STATE SIGNIFICANT DEVELOPMENT NO.5251 - DUBBO ZIRCONIA PROJECT (DZP), TOONGI, DUBBO LOCAL GOVERNMENT AREA

To this end, the following comments are provided in respect of the project and the Environmental Impact Statement (EIS) on behalf of Dubbo City Council.

Figure 1: Detail from the Open Space Master Plan adopted by Council 23 March 2009, Volume 2. Map 7: Connectivity Projects (excerpt). The dashed line marked No.2 is defined as a shared pathway along the railway corridor.

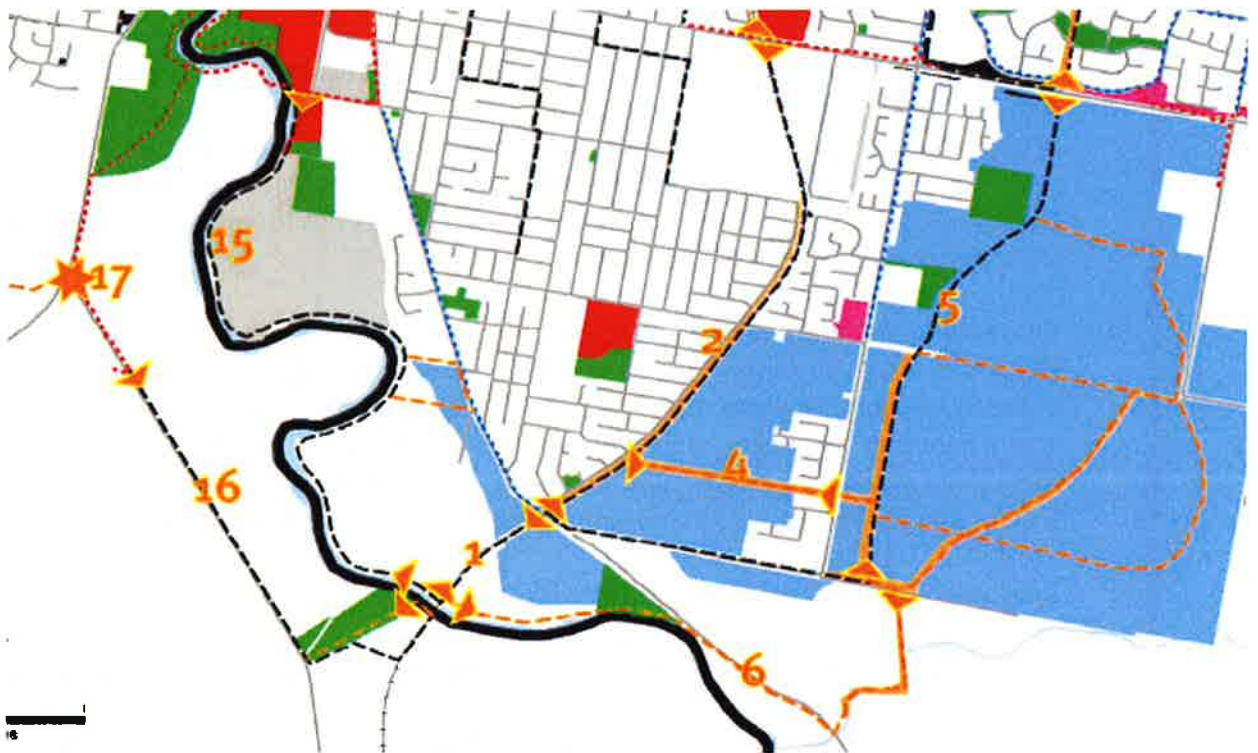
As a result, Council requires on the western side of the rail line the minimum distance possible for safety from the rail track. This will allow the installation of a shared pathway between the road reserve and the fenced portion of the rail reserve. It is Council's preference that the main maintenance track for vehicles be located on the eastern side of the rail line in order for a minimum amount of the rail reserve to remain inaccessible.

Where the dashed line marked 'no. 4' intersects with the dashed line marked '2', Council requires provision of a pedestrian/bicycle crossing. This will allow integration of all pathways within the network and reduce the motivation by the public to damage a fence and access/cross the railway at a number of informal points.

Figure 3: The line marked '3' is defined as a shared pathway link between the shared pathways that run along both Cobra Street and Birch Avenue (Open Space Master Plan Vol 2, Map 7).

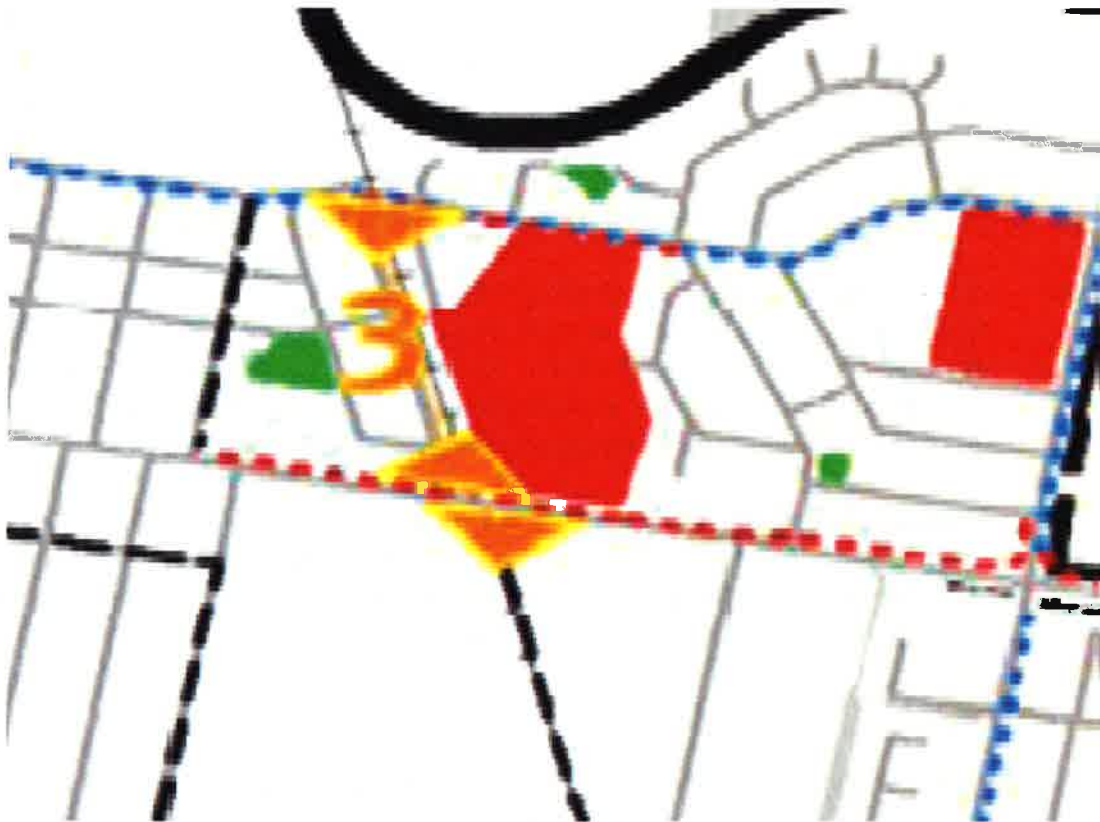
- (g) In the block between Cobra Street and Birch Avenue, there are similar issues with trees and shared pathway crossings. The minimising of enclosure to the west of the rail line should

continue from Margaret Crescent up to and including this block. This will minimise tree loss and will allow the installation of a shared pathway along the Chelmsford Avenue side of the railway corridor (see Figure 3 below). The railway crossings will have to be fenced appropriately as other existing crossings are in the urban area. Apex Oval East Dubbo football complex is a major node in the Open Space network.
